Environmental Assessment Covering CIA's Proposed off-site Road Improvements

Environmental Assessment

Route - I23 - Off-Site Road Improvements
at the C.I.A. Entrance
Fairfax County

State Project 0123-029-000-C.I.A.
0219-A002

ALTERNATIVE 2
Route 123/Route 193 CIA Entrance

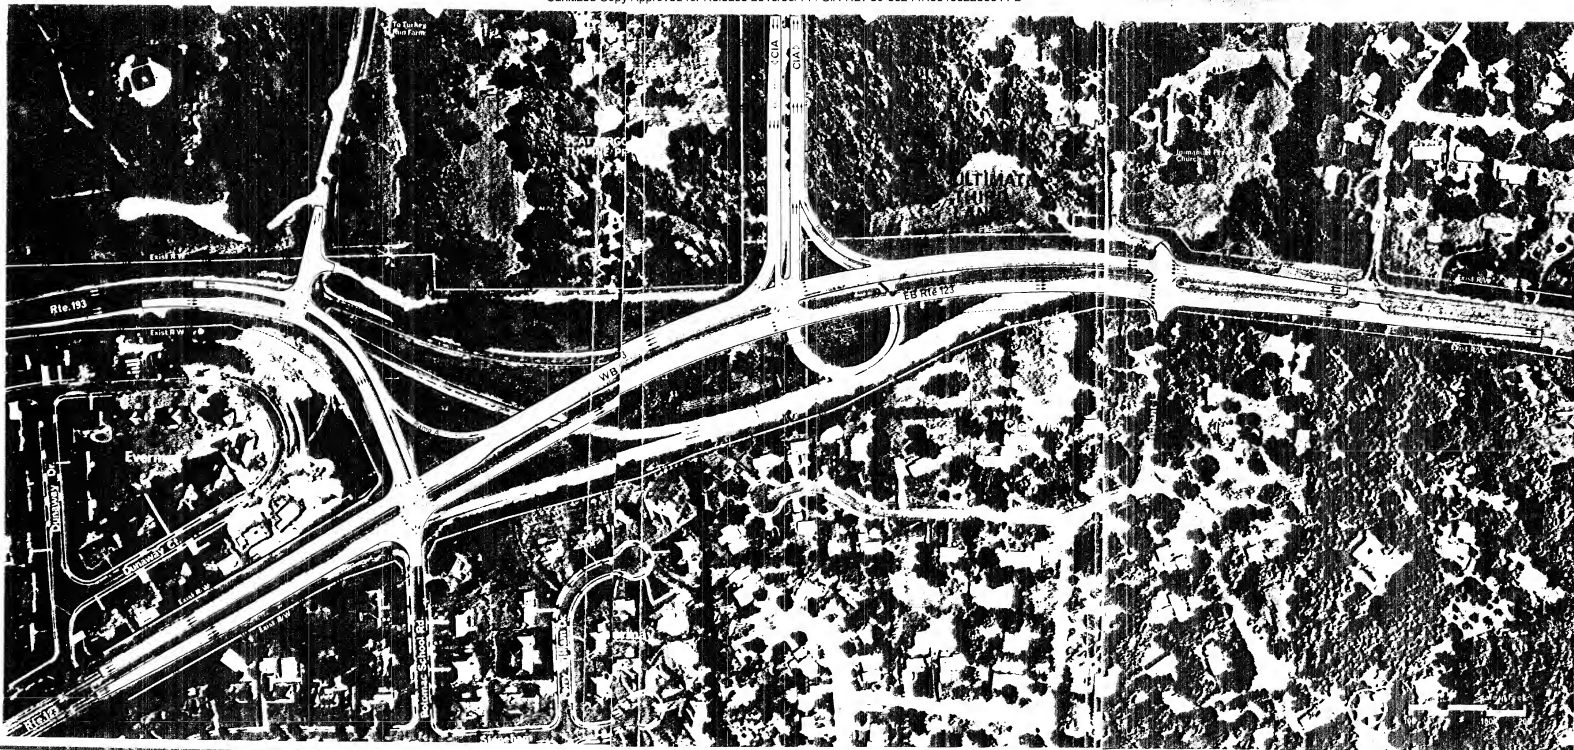
Given that State Route 123 is a major regional highway serving long-distance trips as well as a local roadway serving various communities, Alternative 2 appears to create the best balance of all functional requirements. Alternative 4, on the other hand, appears to create a high-type urban interchange with little consideration of the needs of the local neighborhoods.

While both alternatives provide what is currently a nonexistent through movement of traffic from Potomac School Road to State Route 193, Alternative 4 does not indicate a through traffic movement from State Route 193 to Potomac School Road. Field observations have indicated that at least 10 percent of total morning inbound Potomac School bus and automobile traffic use this movement.. Denial of this traffic movement may require that rerouting and rescheduling of school buses be performed by Potomac School as well as other schools in the area which currently utilize the Potomac School Road intersection.

Of greater importance, however, is the issue of traffic safety. Alternative 4 requires that traffic desiring to cross State Route 123 between Potomac School Road and State Route 193 must cross six lanes of uncontrolled traffic with approximately 26 feet of "shelter zone" created by the median and the left turn storage bays along State Route 123. This width would permit the storage of one automobile at a time within the "shelter zone" in the event gap time along State Route 123 is not synchronized to allow a continuous movement from State Route 193 to Potomac School Road. However, the majority of buses used by Potomac School, as well as those used by other schools within the surrounding area, are approximately 36 feet in length. Alternative 4 denies the opportunity for a typical school bus driver to utilize a "shelter zone" when desiring to cross State Route 123 and therefore requires him/her to cross six lanes of uncontrolled traffic in one continuous movement.

A. Support of Alternative 2, the at-grade solution at the Dolley Madison entrance, rather than Alternative 4, the grade-separated solution, with certain conditions:

1. That the CIA build a short asphalt trail which would provide a connection between the sidewalk on the south side of Route 123 and the trail which is to be built on the north side of Route 193.

2. That the two-way section of Potomac School Road-extended be moved slightly to the east to allow space for an earth berm and landscaping between it and Evermay Section 7.

3. That the existing grade between the eastbound and westbound lanes of Route 123 at Potomac School Road be equalized, to eliminate the slope of Route 123 at Potomac School Road which in bad weather is hazardous to school buses and others.

4. That a signal, synchronized with the signal at the main exit from CIA, be provided at the double right turn to Route 123.

5. That the old eastbound pavement bordering Evermay and Clearview Manor be removed and replaced with landscaping for noise control, except for a four-foot wide strip of pavement paralleling the new eastbound lanes which would function as a trail.

It is the clear consensus of the surrounding communities that alternative #2 which provides for an at-grade solution is preferable to alternative #4. We, therefore, support alternative #2 with the following changes:

- a. Route 123 be graded and paved as a four lane road only.
- b. A berm be erected on the east end of Evermay Section 7 such that the Route 193 spur is realigned approximately 60-80 feet east of its present location to facilitate traffic proceeding from Potomac School Road to Route 193 northbound.
- c. The number of lanes on Route 193 at the intersection of Route 193 and Potomac School Road be limited to three - one northbound and two southbound.
- d. A "trip" (or appropriate other) signal be installed at the intersection of Saville Lane and Route 123.
- e. More definitive descriptions of signing and landscaping be provided prior to the conduct of a public informational meeting.
